ENTERGY OPERATIONS, INC.

ARKANSAS NUCLEAR ONE, UNIT ONE

Subject: Arkansas Nuclear One - Unit 1
Docket No. 50-313
License No. DPR-51
Proposed Technical Specification Change Revising The Pressurizer Code Safety
As-Found Setpoint Tolerance

DESCRIPTION OF PROPOSED CHANGES

Figure 1 of
1CAN049606

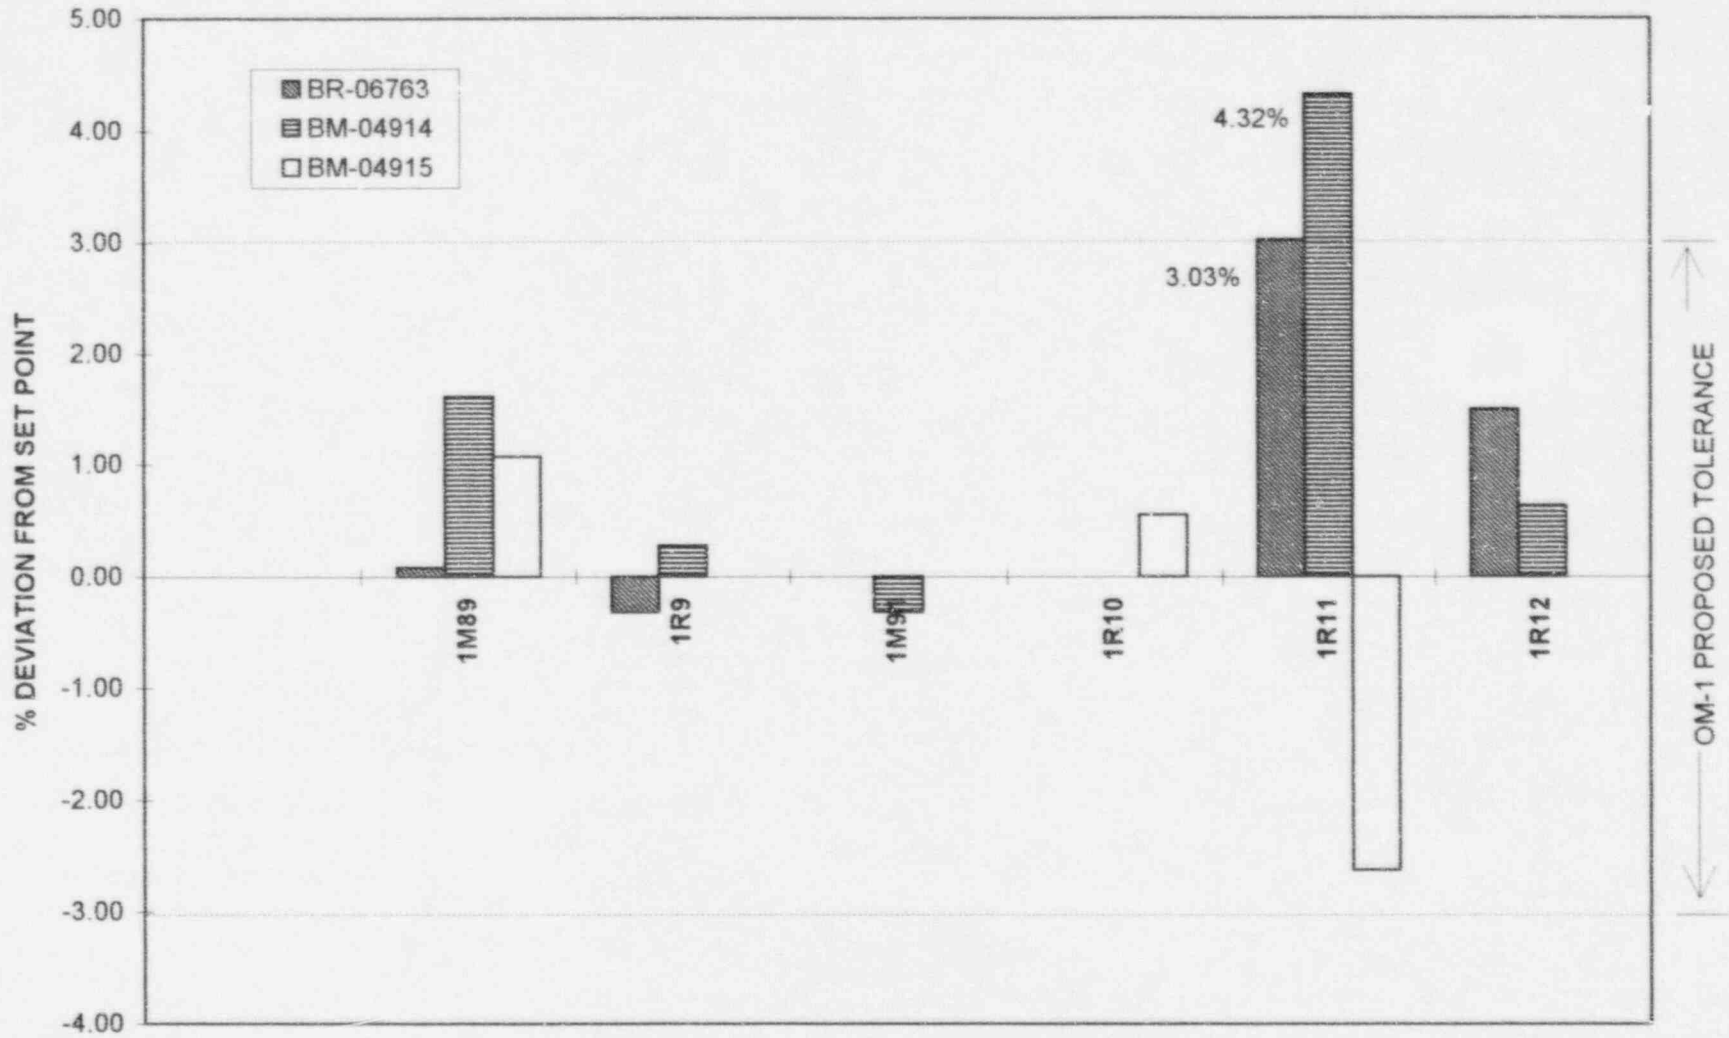
Testing results since 1M89 are summarized in Figure #1 attached to this submittal) for all three ANO-1 pressurizer code safety valves (two valves are in service and one is a spare).

As shown in Figure #1, two of the twelve tests conducted since 1M89 were not within the proposed setpoint tolerance of $\pm 3/-3\%$. The high setpoints both occurred during 1R11 and were attributed to the practice of "jack and lap" after setpoint testing. This process allowed the valve to be partially disassembled, leaving the spring intact, in order to lap the seats to eliminate post testing leakage. After the process was completed, the valve was re-assembled without further setpoint testing. Based on recent information, this repair method can not be used on the Dresser valves without re-verifying the setpoint because the valves utilize four spiral wound gaskets between the body to bonnet interface. Since the gaskets may not compress to the same degree after re-assembly, the spring compression could change thus affecting the setpoint. After both valves lifted out of tolerance during 1R11, the spare valve which had been in storage since 1R10 was tested, and also lifted out-of-tolerance. Since this valve had also been "jack and lapped" without re-verifying the setpoint in 1R10, the practice of "jack and lap" without subsequent setpoint verification was determined to be questionable. Now, if a valve is "jack and lapped," its setpoint must be re-verified.

During 1R12, PSV-1001 lifted 1.5% above setpoint. Because the valve lifted out of the current setpoint tolerance of $\pm 1/-3\%$, PSV-1002 also had to be tested to meet code requirements. PSV-1002 was found 0.64% above its setpoint. Expanding the setpoint tolerance range to $\pm 3\%$ would reduce the likelihood of a valve being found out of tolerance. This in turn would reduce the probability of subsequent valve testing during each outage.

Figure 3.1.3-1

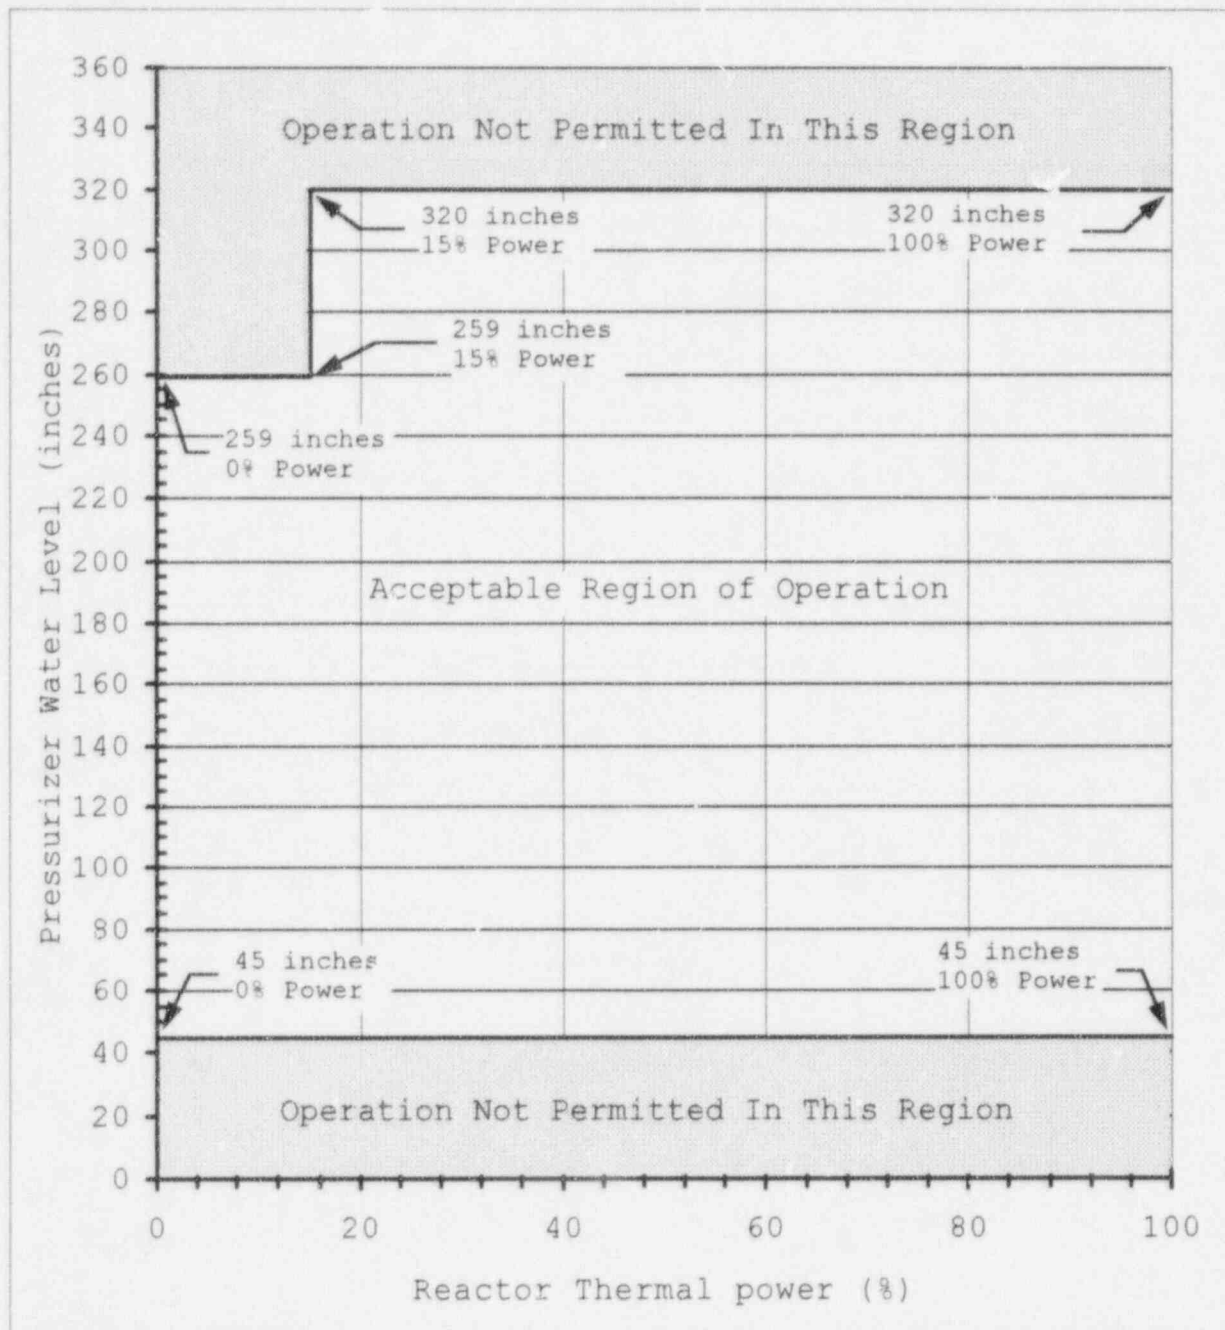
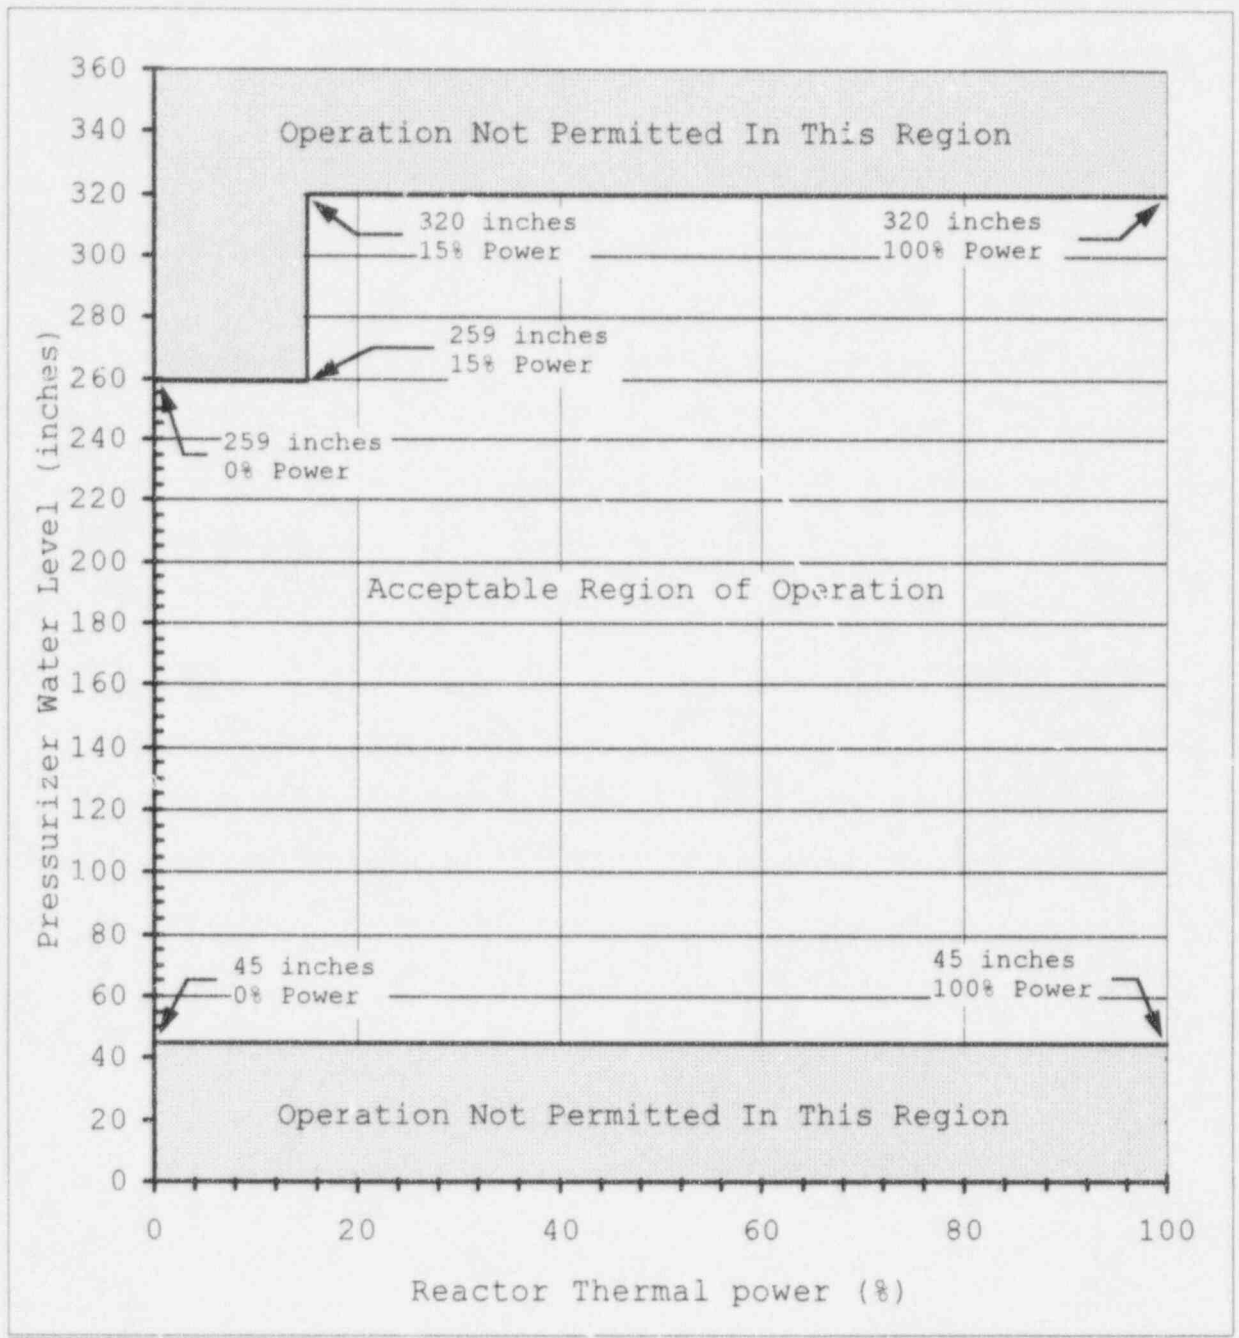
- The pressurizer water level requirements of Specification 3.1.3.4 have been revised to refer to Figure 3.1.3-1, Pressurizer Level Acceptable Range.
- A new page has been inserted to allow incorporation of a new figure. Figure 3.1.3-1 shows the acceptable ranges for pressurizer water level as a function of reactor power, as required by the revised Specification 3.1.3.4.

A new figure, Figure 3.1.3-1, has been added on inserted page 21a specifying the acceptable range for pressurizer level as a function of reactor power. The minimum pressurizer level for all power levels remains at the currently specified 45 inches. From 0% to 15% Rated Power, the pressurizer maximum water level is 259 inches. From 15% to 100% Rated Power, the pressurizer maximum water level is 320 inches.

Figure 3.1.3-1 also contains a note to clarify that the specified pressurizer levels and reactor power levels do not contain an allowance for instrument error. The previous pressurizer level requirements were specified as "indicated" levels. No reference was made in the associated Bases to indicate whether instrument error was included in these limits. Since the values for pressurizer level and reactor power used as inputs to the startup and rod withdrawal analyses were not corrected by the inclusion of instrument error, this note indicates that values used for controls in the plant procedures should be corrected for the instrument error allowance.

- 3.1.3.4 The reactor shall be maintained subcritical by at least 1 percent $\Delta k/k$ until a steam bubble is formed and a pressurizer water level within the limits of Figure 3.1.3-1 is established.

- 3.1.3.4 The reactor shall be maintained subcritical by at least 1 percent $\Delta k/k$ until a steam bubble is formed and an ~~indicated water level between 45 and 305 inches is established in the pressurizer~~ water level within the limits of Figure 3.1.3-1 is established.

FIG. NO.
14-4

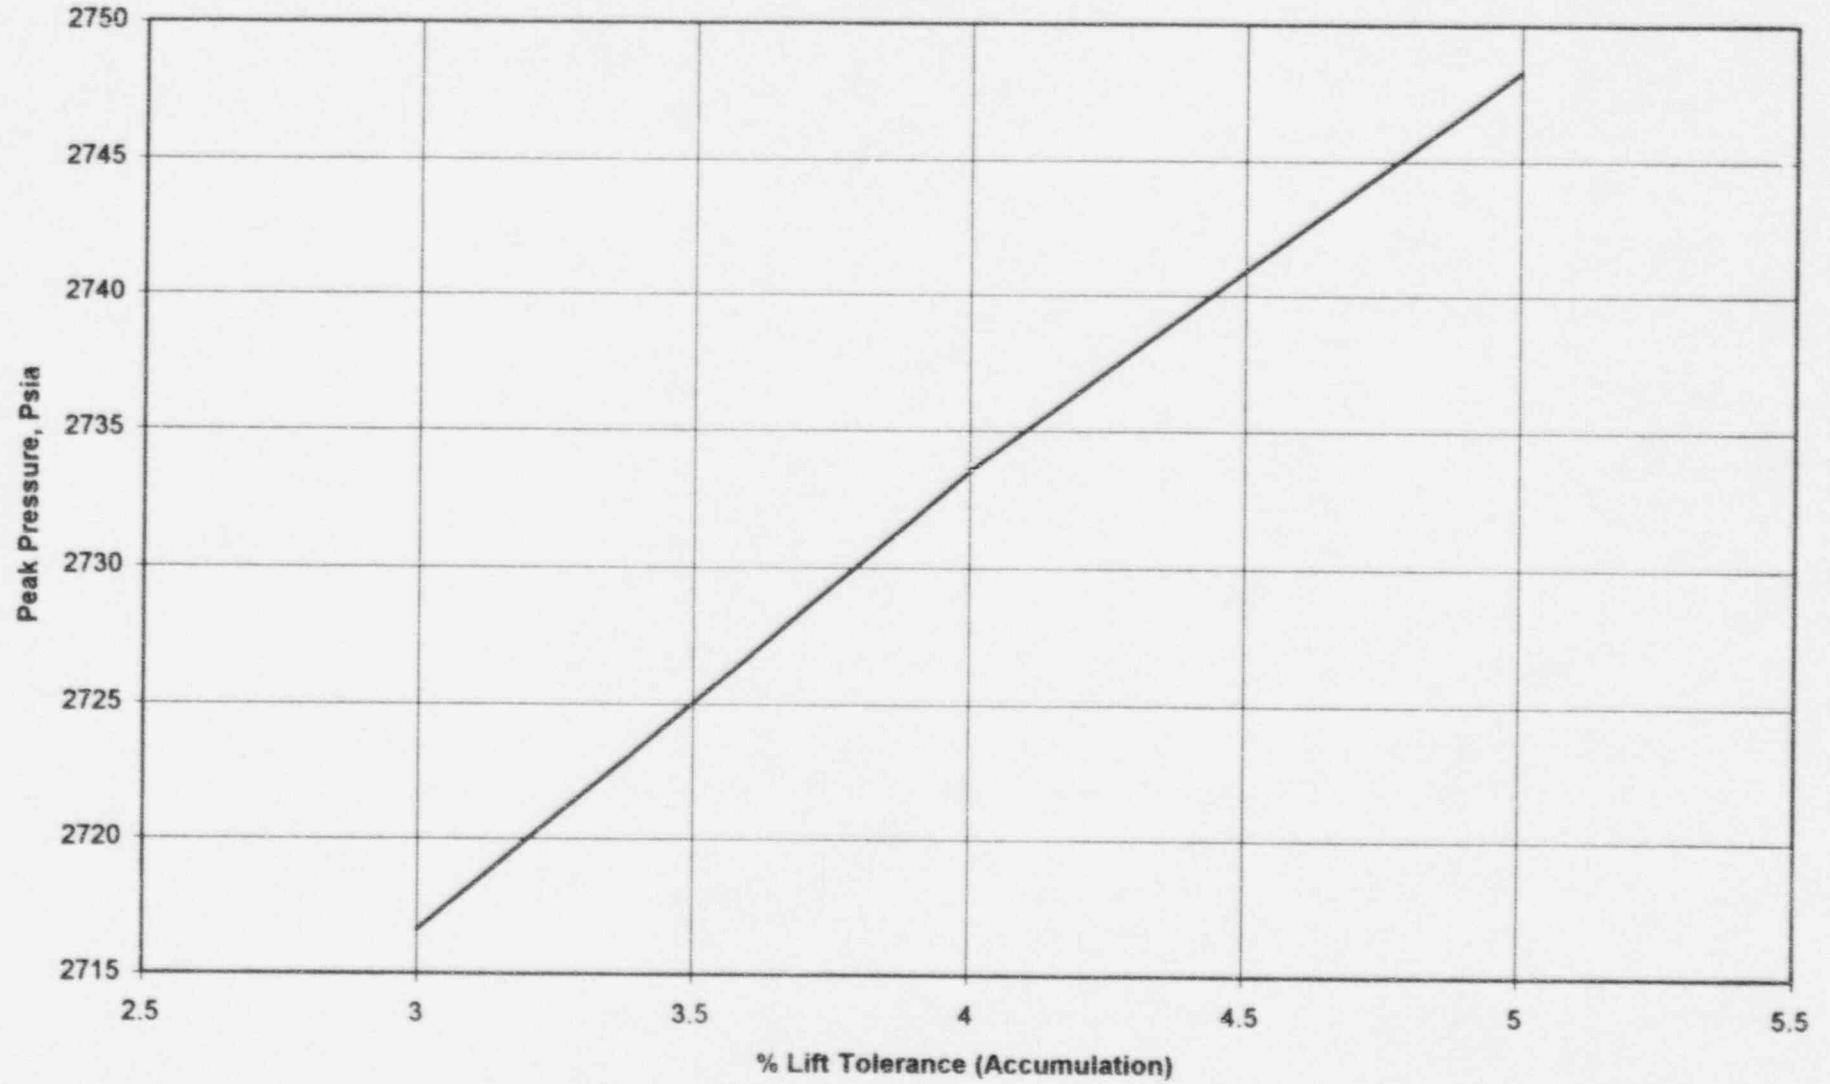
Figure 14-4 shows the effect of varying the pressurizer safety valve (PSV) lift setpoint tolerance (accumulation) from 3% to 5% (assuming all other inputs remain constant).
